Office Action Summary	Application No. 10/824,110	Applicant(s) EISENBRAUN, KENNETH D.	
	Examiner Jon A Szumny	Art Unit 3632

This is the first office action for application number 10/824,110, Merchandising Hanger, filed on April 14, 2004.

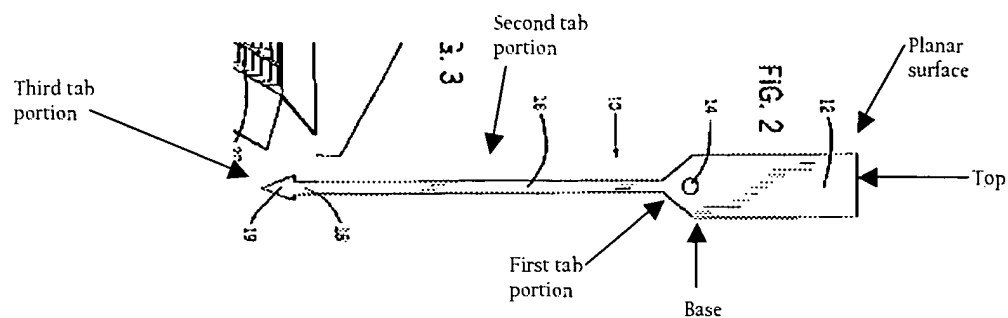
Regarding claims 3 and 13, it is stated, "there is an opening adjacent to the base of the stud and the first tab portion or the third tab portion integral therewith." However, if there is such an opening, as is presumably shown in figure 4 (not labeled), it is not understood how the stud would be able to be attached to either the first or third tab portion. Further, such openings 38 do not appear to be "openings" in figure 3.
